OUR REF: Q000233  
CONCIL REF: A006746826

23 April 2026

**A006746826 – RESPONSE TO FURTHER ADVICE REGARDING MINOR CHANGE APPLICATION - LOCATED AT 46-50 LATHAM STREET, CHERMSIDE, FORMALLY DESCRIBED AS LOTS 140 AND 141 ON RP26297 AND LOT 139 ON RP54239**

**Figure 1: RCV zone**

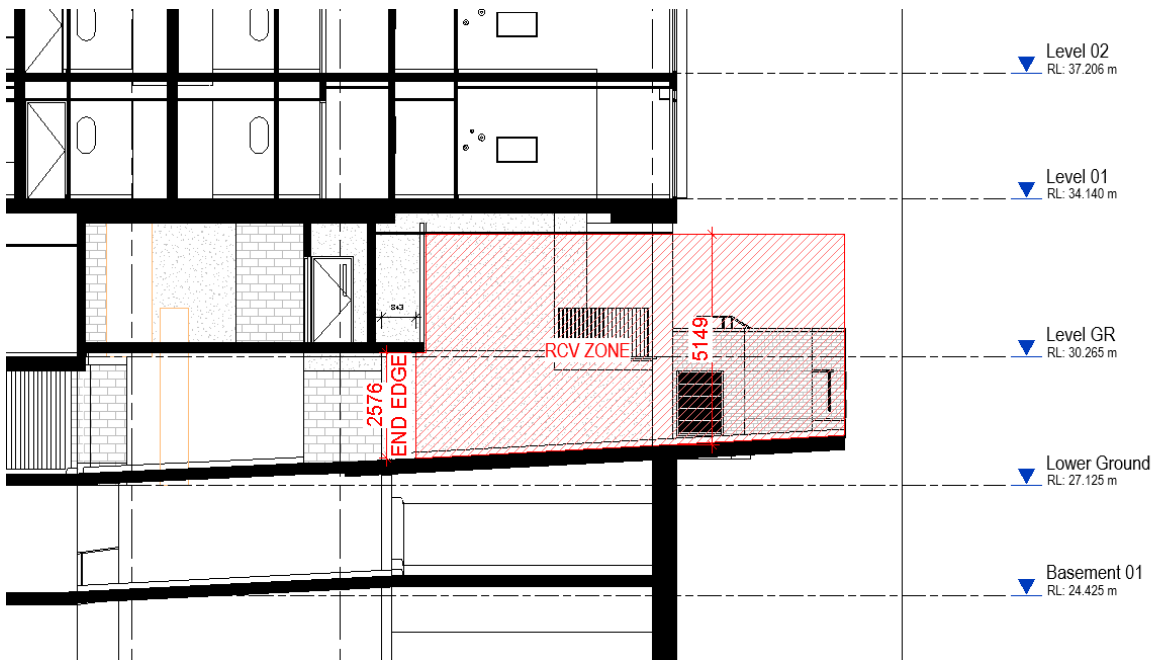
*The swept paths provided, including that of an MRV, incorrectly assume manoeuvring to the kerbside on the site frontage. Parking in Latham Street is permitted on the site side of the road and is prohibited on the opposite side of the road. Therefore, manoeuvring would be undertaken from adjacent to the kerbside opposite. It appears that a BCC RCV would be able to reverse on to the site with a small "No Stopping zone" to the west of the crossover. However, this needs to be demonstrated.*

- a. *Provide amended swept path reversing on to the site (identifying any parking restriction limited to the absolute minimum necessary).*
- b. *Show the height clearance to the line of the building where the service vehicle is to be standing for service.*

We refer Council to **Attachment 3** showing the swept path for the RCV.

**Figure 1** below shows a 5.149m height clearance for the RCV zone.
